October 12, 2004

All Holders of The City of Springfield's  
"Design Standards for Public Improvements",  
"Standard Drawing Details for Public Improvements",  
Dated 05-10-2002

RE: Submittal Standards

SECTION "A-A"

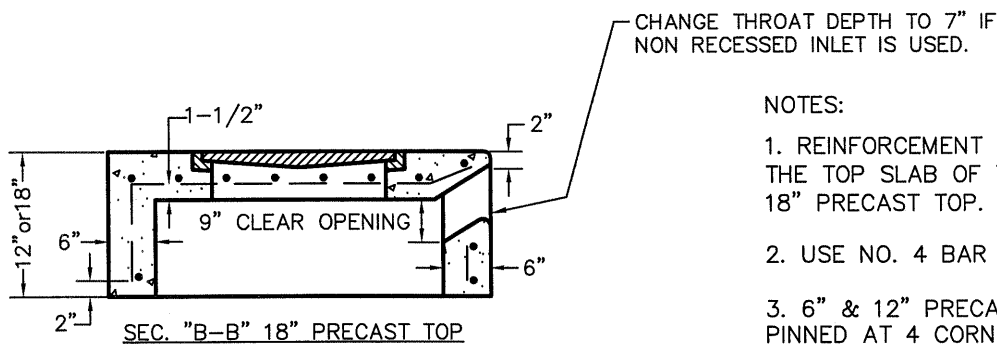
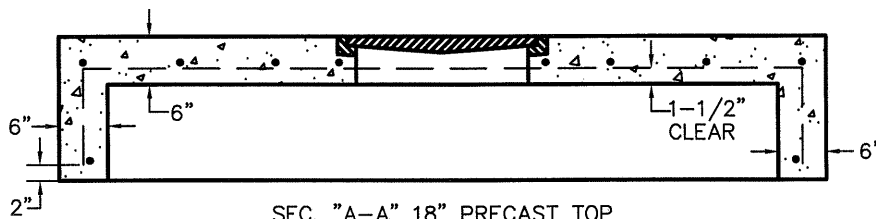
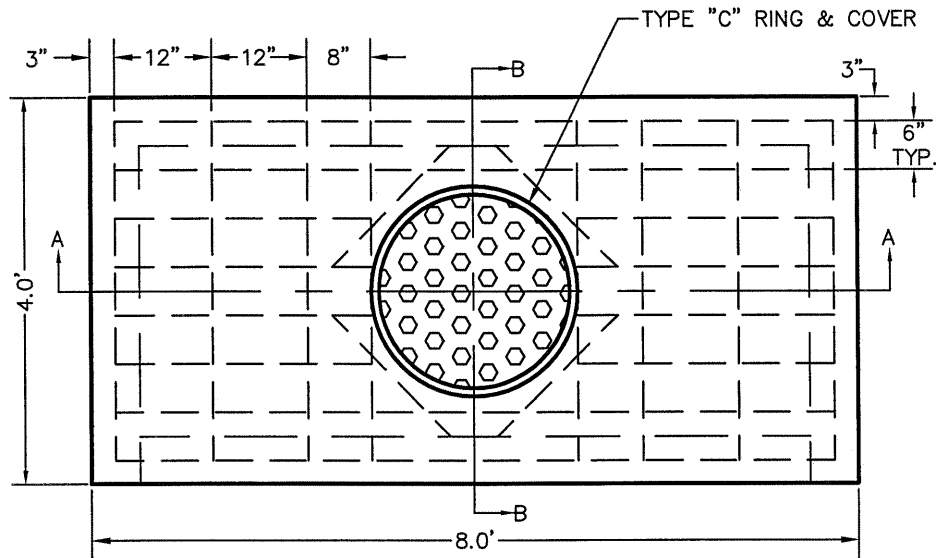
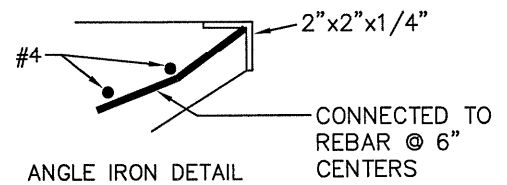
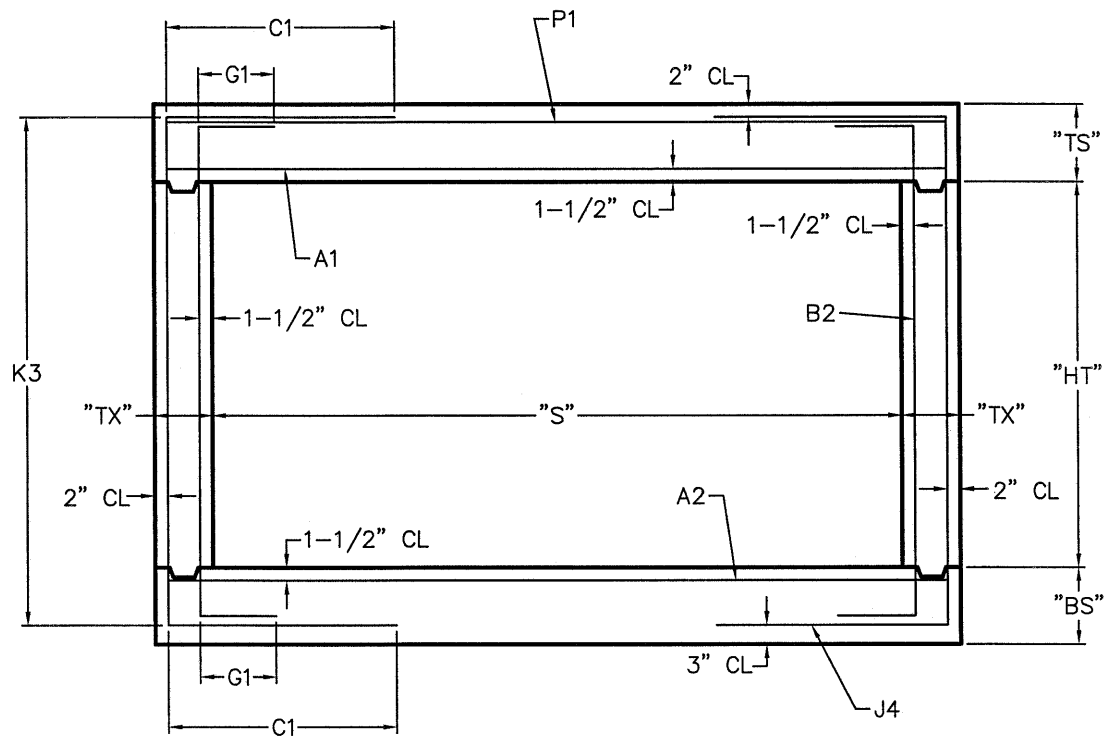
1. Replace existing drawing ST-7, Mailbox Replacement, with revised ST-7 dated 10-01-04. This corrects the height location of the mailbox to meet mail delivery standards.
2. Remove Drawings SS-5, SS-6, SS-6-R and SS-8 and replace with drawings SS-6 dated 10-01-04 and SS-8 dated 10-01-04. These two drawings change the curb inlet to requiring recessed curb inlets as the standard curb and gutter inlet.
3. Add drawing SS-15, concrete box culvert minimum reinforcement details. This standard is to be included on all plans requiring a box culvert as part of the project.
4. Insert sheets V-22 a, b, c & d, Revised October 7, 2004, Plan Review Checklist for Sanitary Sewers.
5. Add Drawing ST-18, Handrails. This drawing details the handrail material to be used when handrails will be exposed to the weather.
